Office Action Summary

10/590,461

MACDOUGALL, JOHN

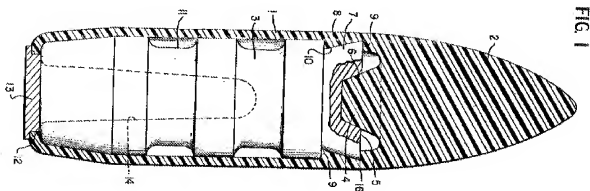
3. With respect to claim 1, Studler discloses a projectile having an engravable jacket 4; and a central cylindrical core 1 having an annular grooves 2, 3 at its "midsection portion". The grooves 2, 3 discontinue contact between the core 1 and the

jacket 4 at those locations. The midsection grooves taper toward both ends of the projectile.

4. With respect to claims 2-4, the gap formed by the tapered grooves 2, 3 fully encircle the core 1 and form a space between said jacket 4 and said core.
5. With respect to claim 5, the midsection tapers and is therefore frustoconical in shape.
6. With respect to claims 10 and 11, the grooves 2, 3 are comprised of empty space and therefore occupied by air.
7. With respect to claim 14, Figures 1 and 2 show the core 1 having an ogival shape. The junction between the forward and the midsection provides a "smooth" transition zone.
8. With respect to claim 15, Figures 1 and 3 appear to show the rear of the core 1 tapering inward.
9. Claims 1-4, 8, 10, 11 and 23 are rejected under 35 U.S.C. 102(b) as being anticipated by US 3348486 issued to Rapp.
